DRAFT
MAP Series of PWR Shipping Packages
Amendment to Certificate of Compliance
USA/9319/B(U)F-96
Docket 71-9319

June 9, 2009
Rockville, MD

Revised Licensing Documents

Drawing 9045404 Revision 1

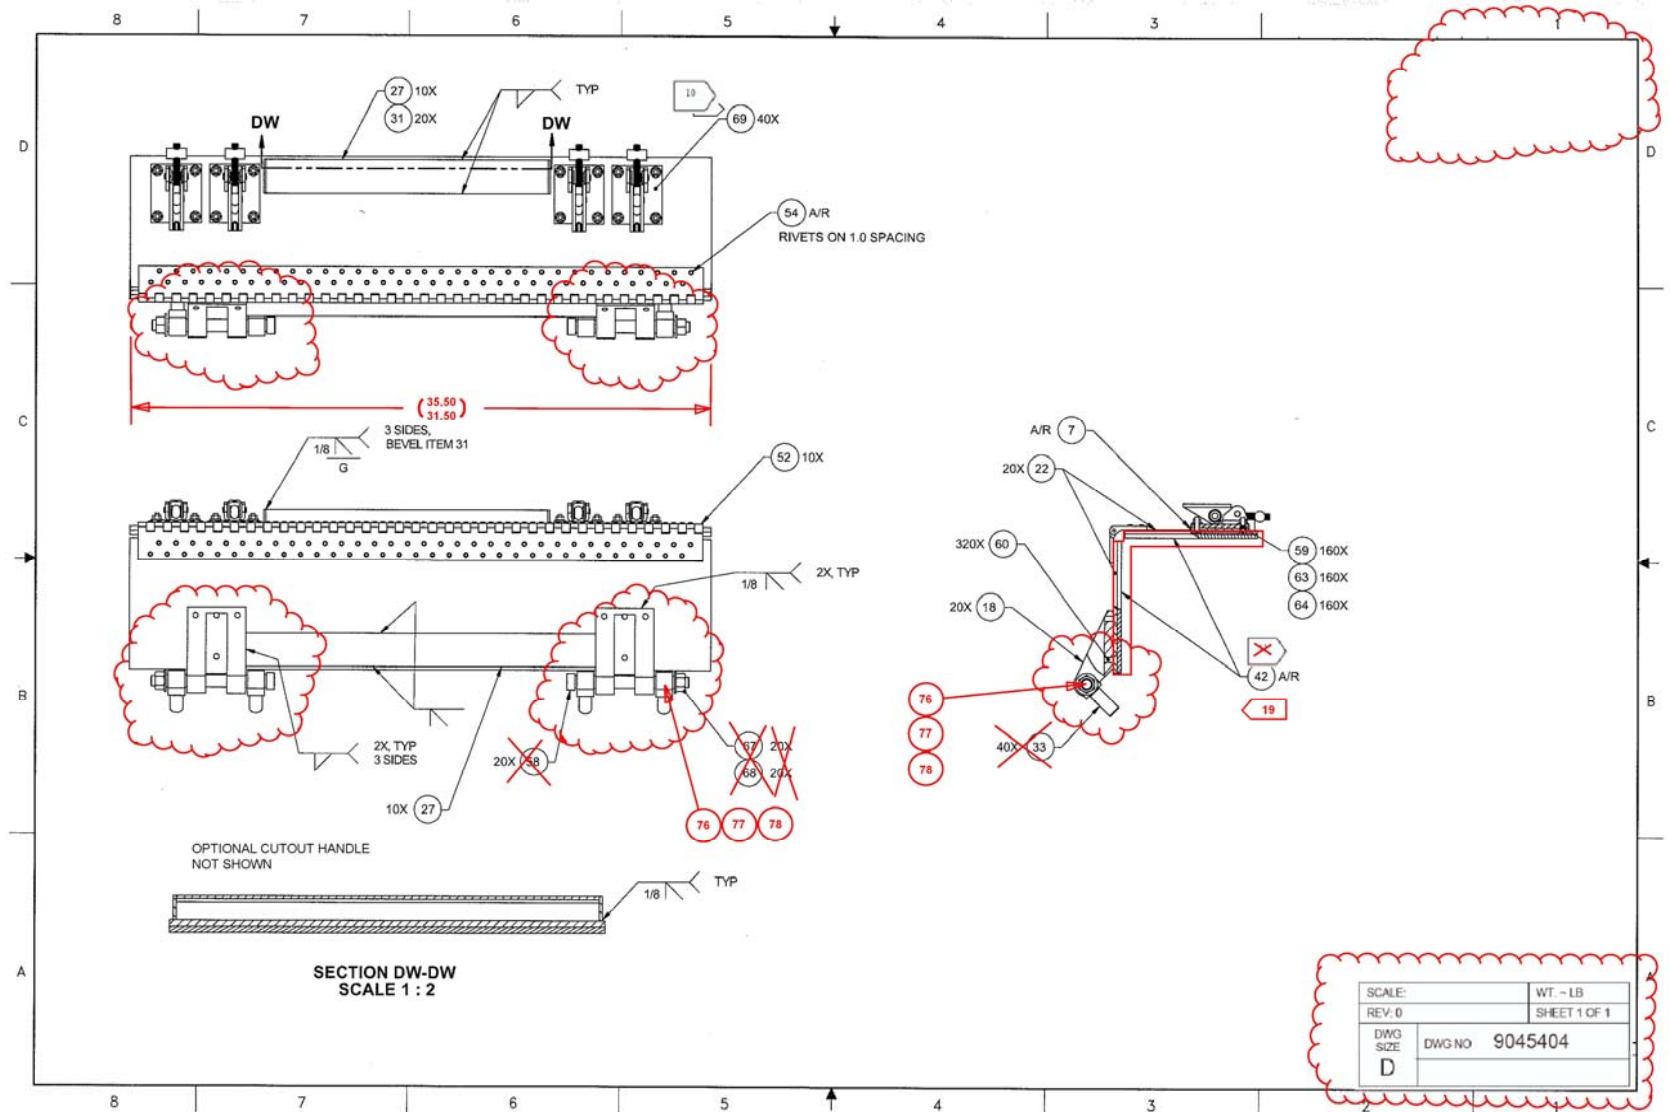
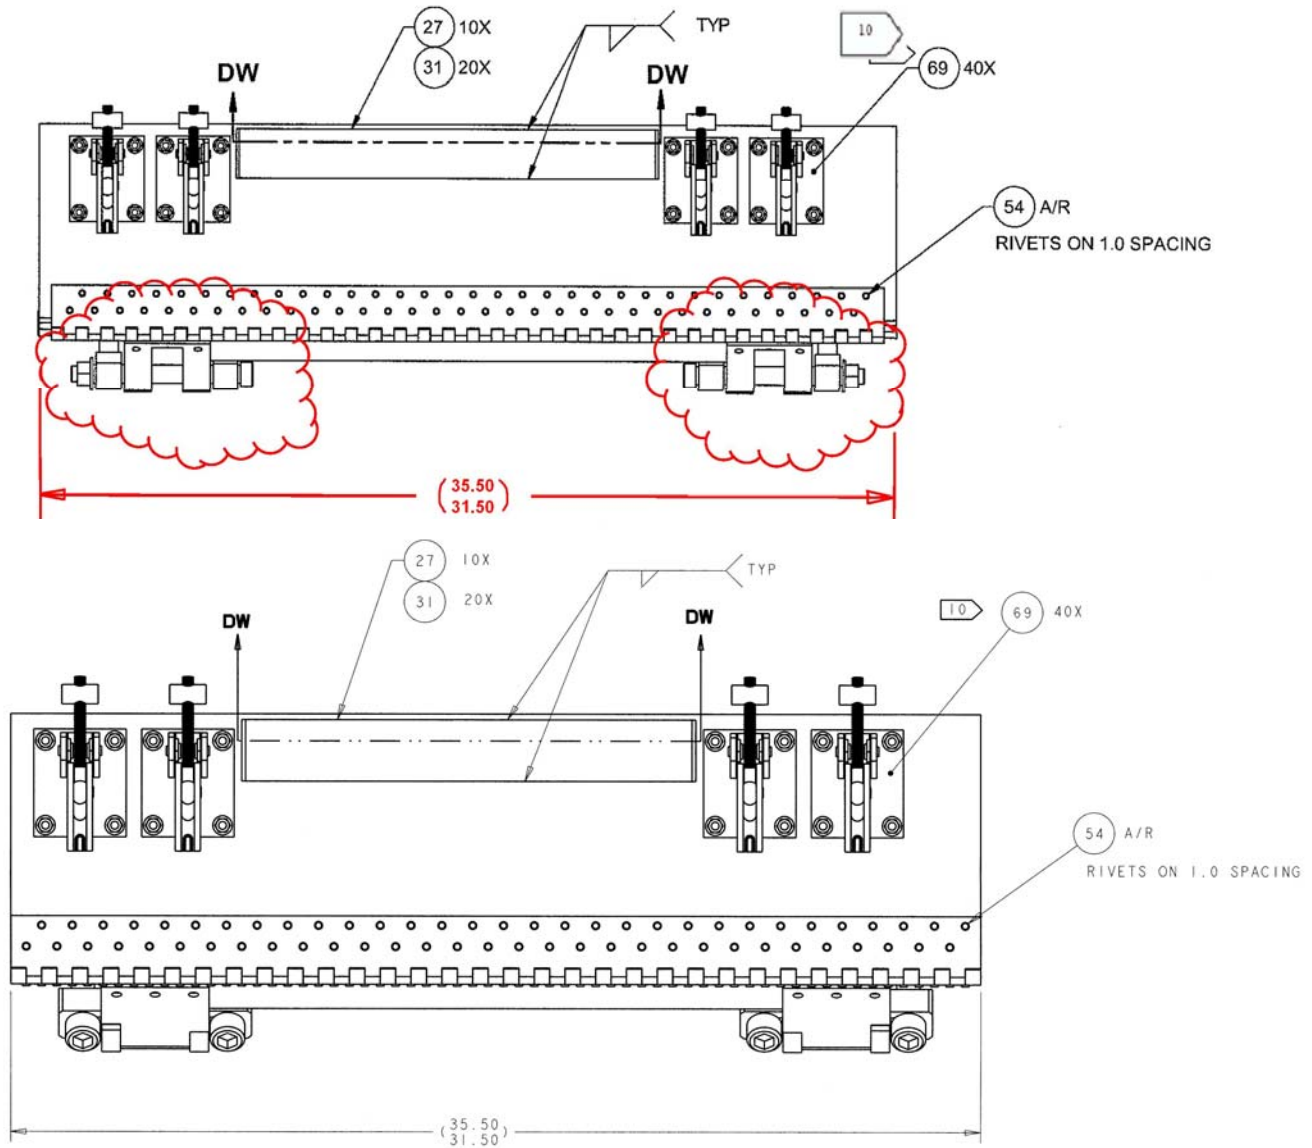
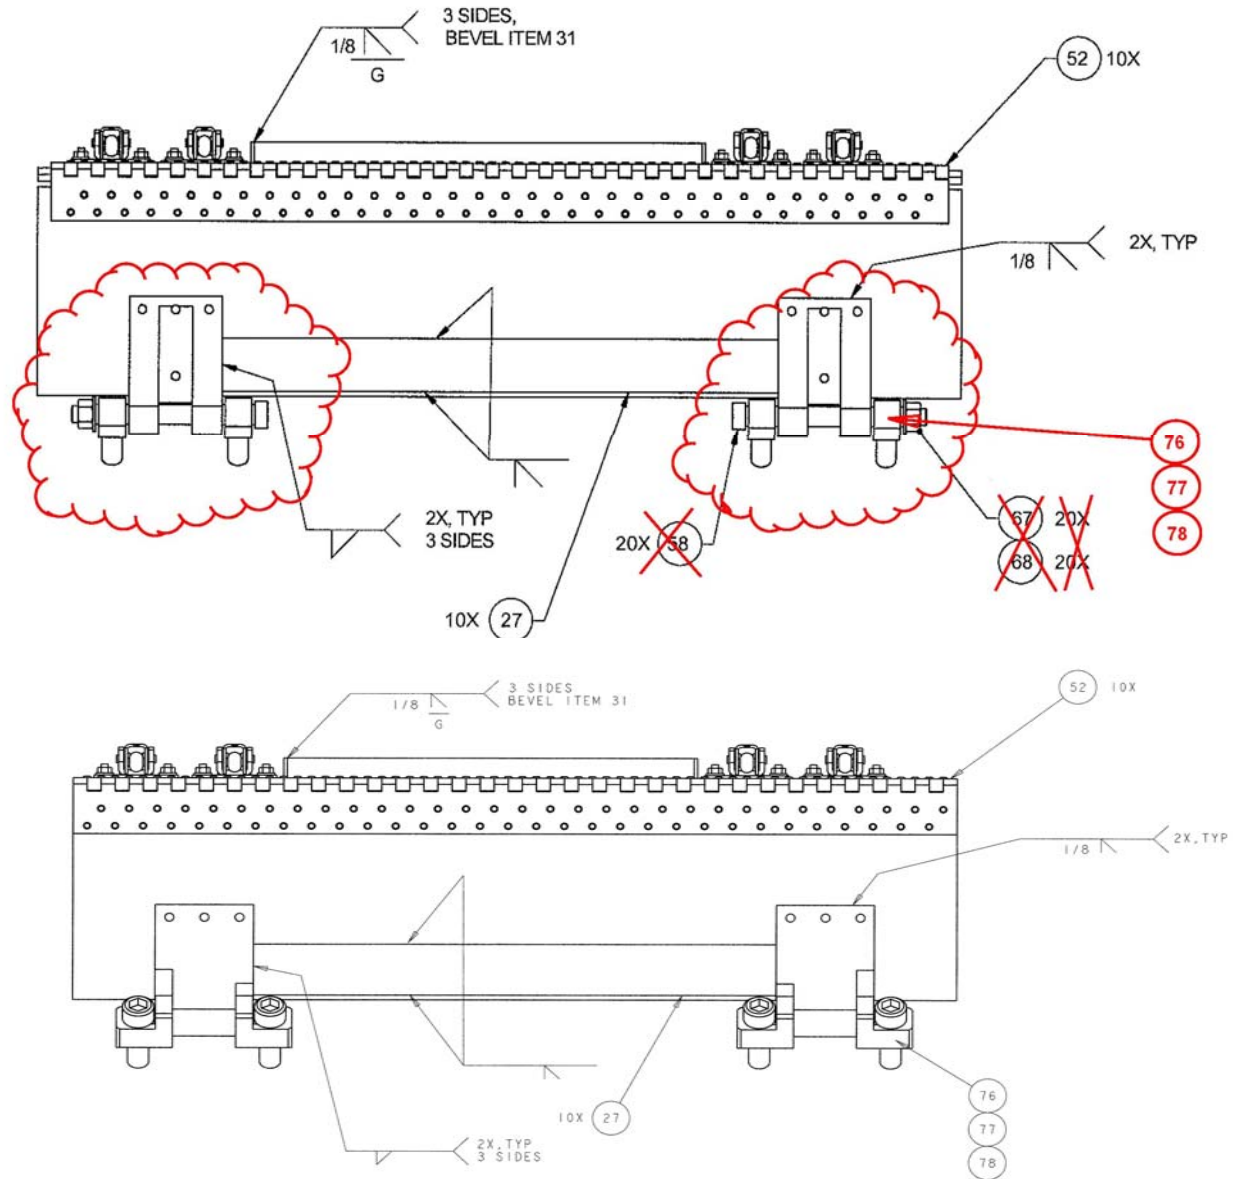
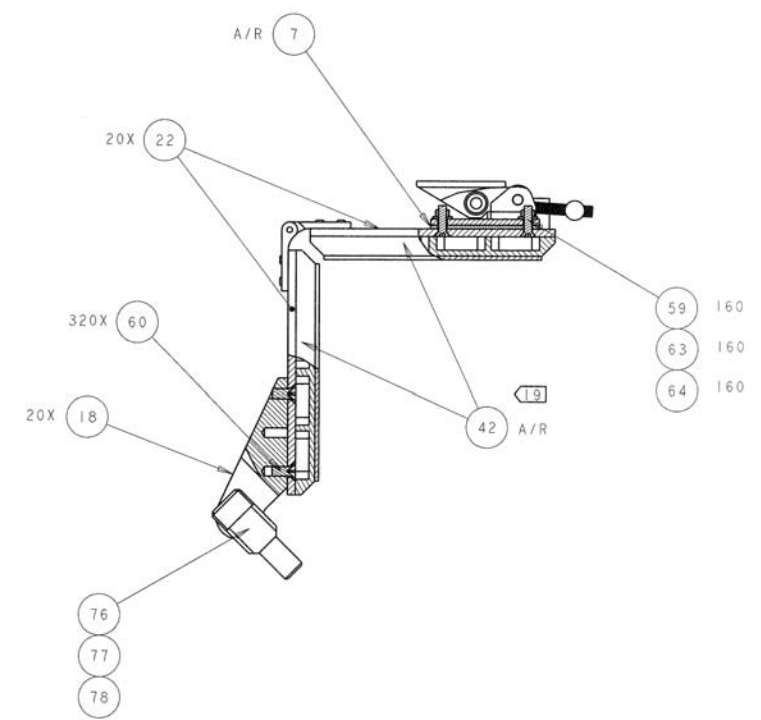
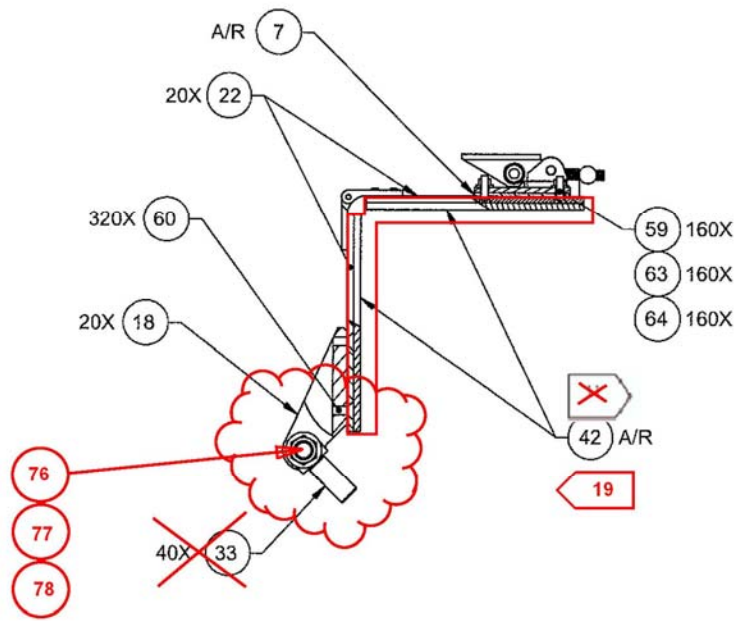
- ◆ ***Recreated in CAD system***
- ◆ ***Updated to reflect current door hinge configuration and applicable items***
- ◆ ***Updated balloons and note pointer***
- ◆ ***Added lengths to differentiate between MAP-12 and MAP-13***

- ◆ ***Clarification***

No impact regarding the performance of the container under accident conditions.

Drawing 9045405 Revision 1

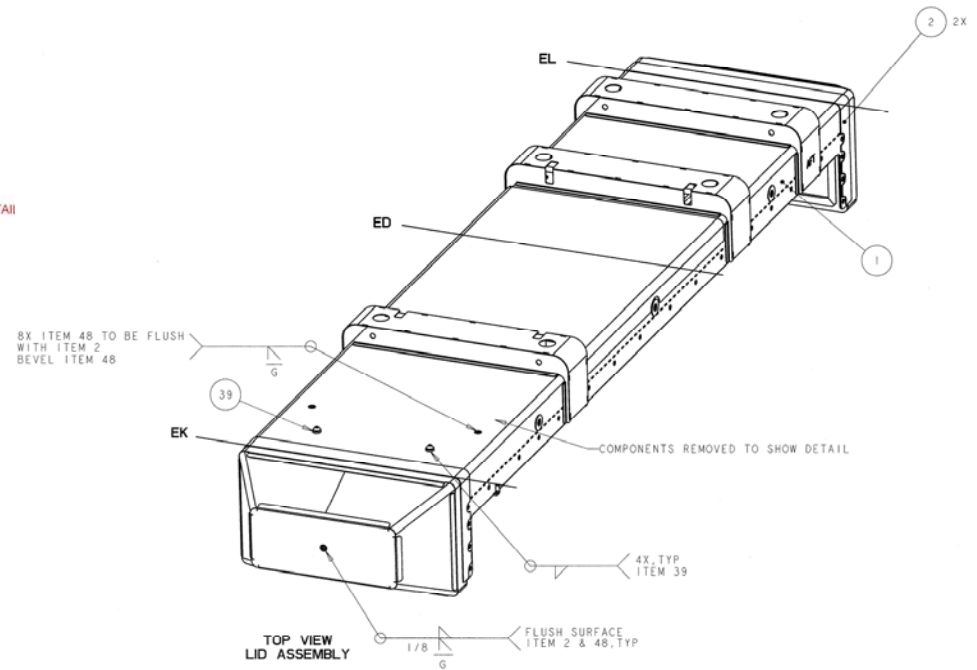
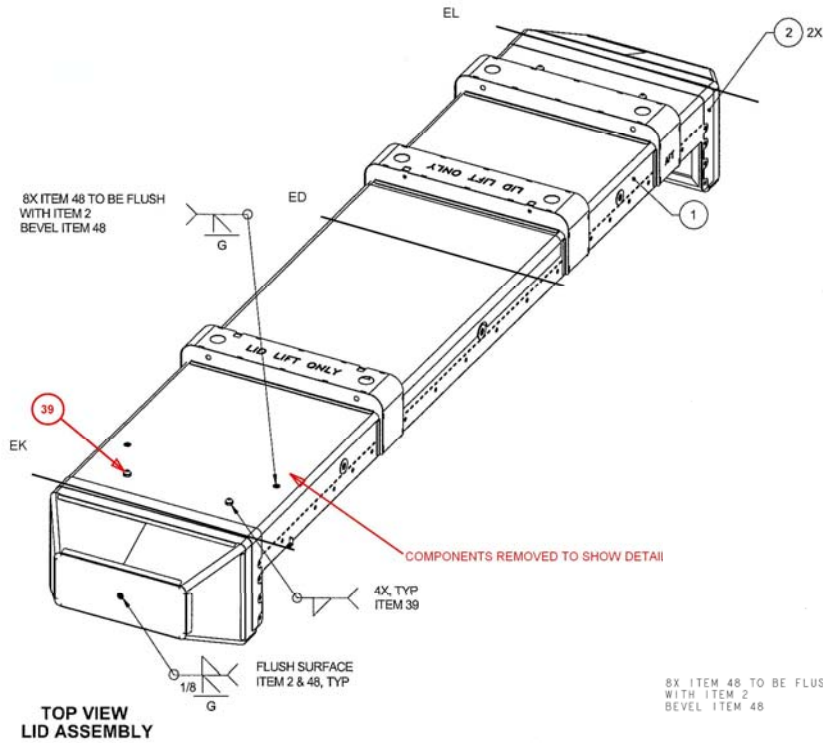
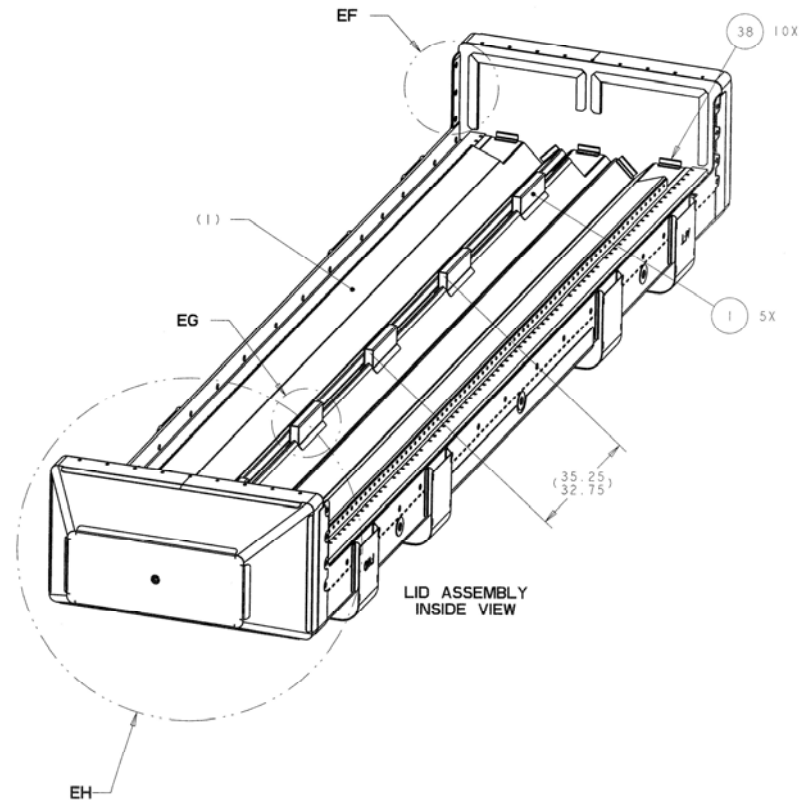
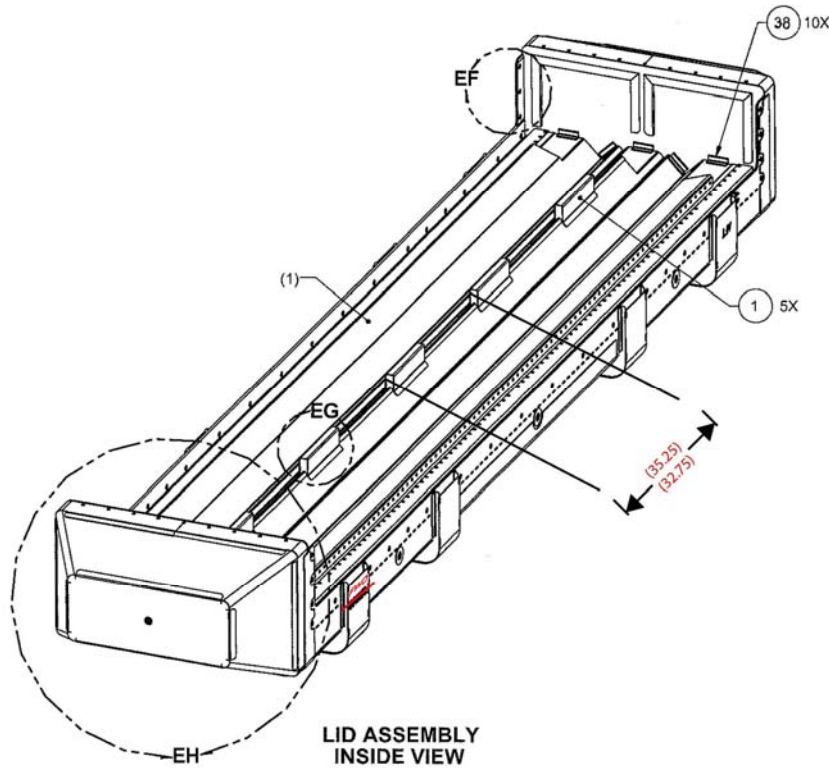
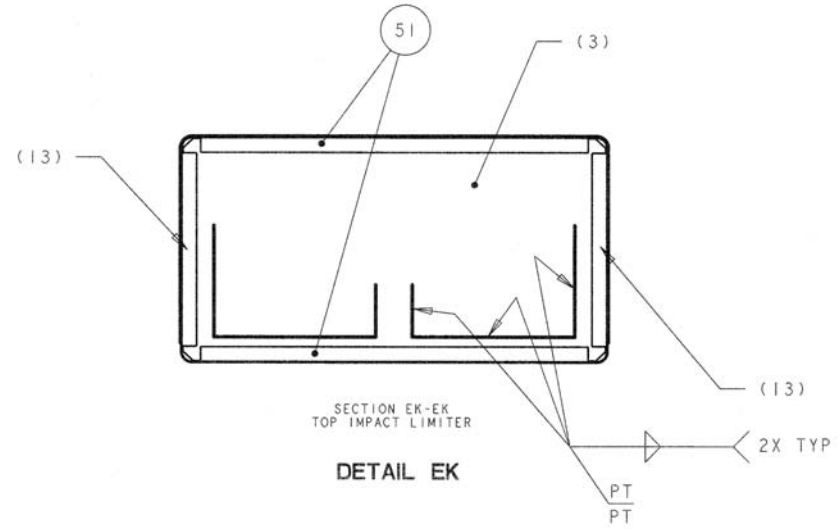
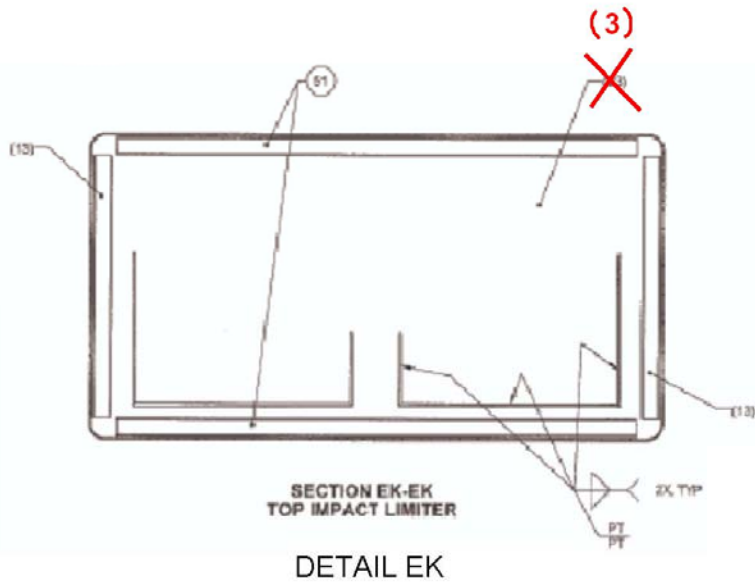
- ◆ ***Recreated in CAD system***
- ◆ ***Removed “Lift Lid Only”***
- ◆ ***“FWD” on container was “Forward”***
- ◆ ***Added balloon, note and detail***
- ◆ ***Updated isometric view note***
- ◆ ***Added lengths to differentiate between MAP-12 and MAP-13***

- ◆ ***Clarification for isometric view cut-away***

No impact regarding the performance of the container under accident conditions.
